# Composite Rear Wheels - w/ Hublocks, w/o Handrims
(12" Wheels)

12" Rear Wheels (Before 7/8/11)

12" Rear Wheels (After 7/7/11)

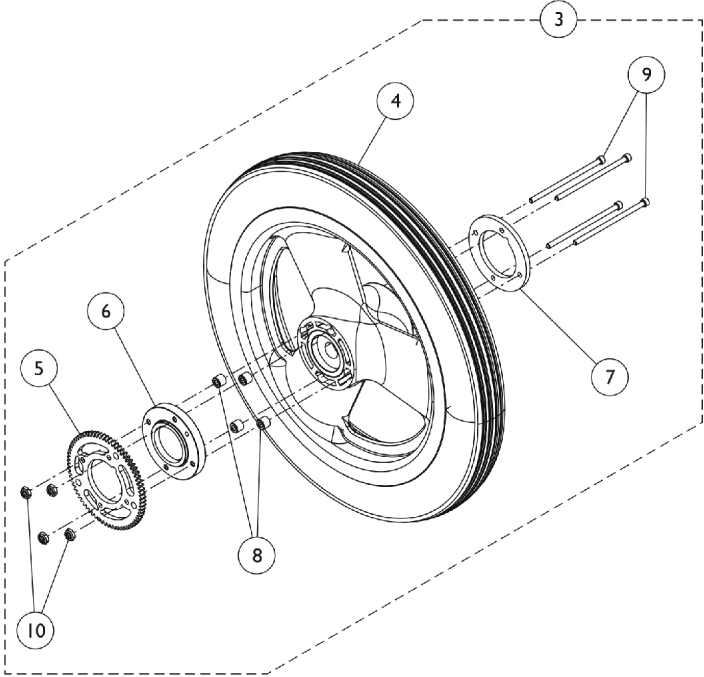
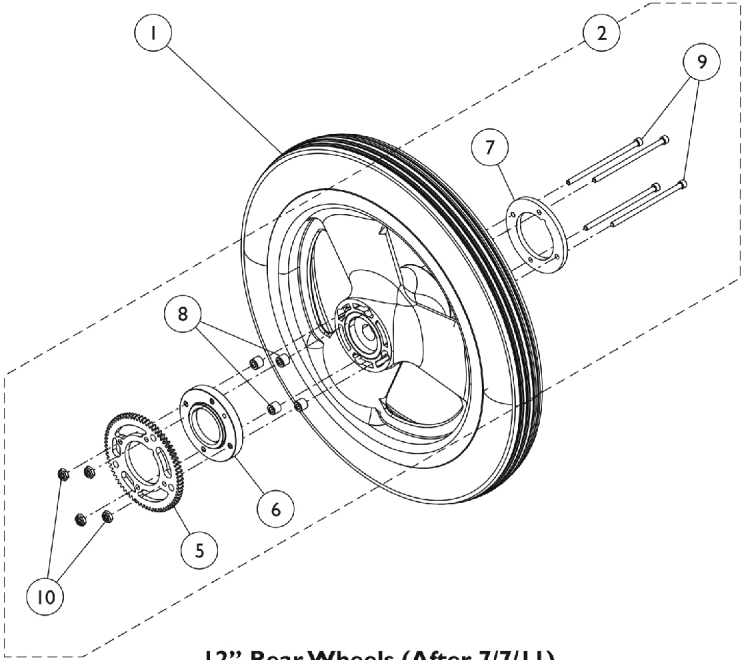
NOTE: A - Includes items 5 - 10.
B - Includes items 4 - 10. When replacing a wheel with Hublock that originally used six screws on chairs manufactured before 7/8/2011, Item #3 (1169314 or 1169315) must be ordered because the new Hublock design only uses four.

NOTE: A - The 12" Wheel only accommodates a Hublock that uses four attaching screws. Existing 12" wheels in the field that have six attaching hole locations must be replaced with item #3 (1169314 or 1169315).
